MEMORANDUM

To: Design Review Board
From: Scott Guter, AICP, Associate Planner
Date: July 5, 2019
File No.: DRV19-00306
Subject: **KIRKLAND URBAN SOUTH (PHASE 2) PROJECT
DESIGN RESPONSE CONFERENCE**

10 Access Street at Southern Property Line - revised diagram

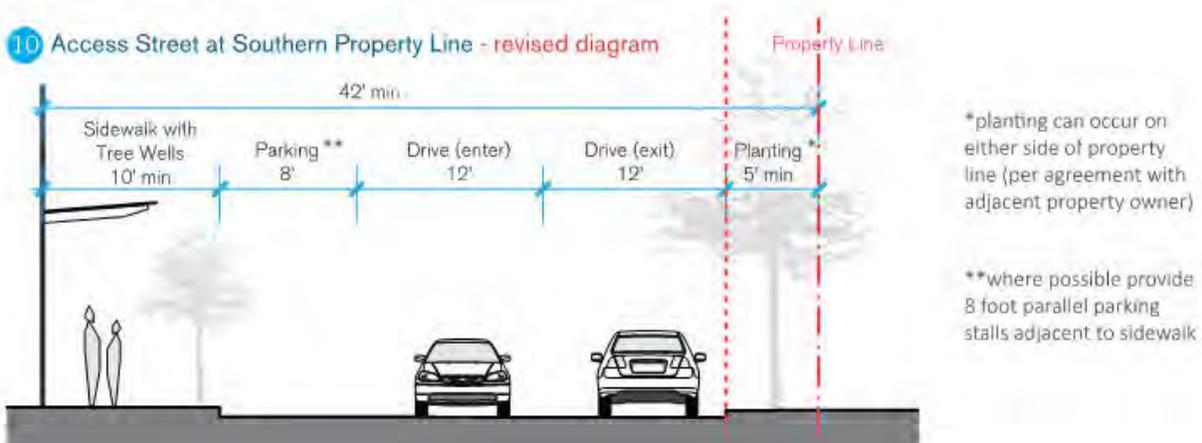
Please refer to the landscape and site plans for dimensions of this roadway. There are slight deviations in the sidewalk width at the northern portion of the theatre frontage to accommodate an accessible ramp. See site plan and landscape plan. In addition, the MRM property to the south (434 Kirkland Way) has shifted their portion of this roadway to the west, leaving an 8 foot sidewalk and no landscape buffer at the west property line. Therefore, the portion of Peter Kirk Lane adjacent to KU South will need to jog to be in alignment. This results in a reduction to the landscape buffer to make the transition of roadway and sidewalk.
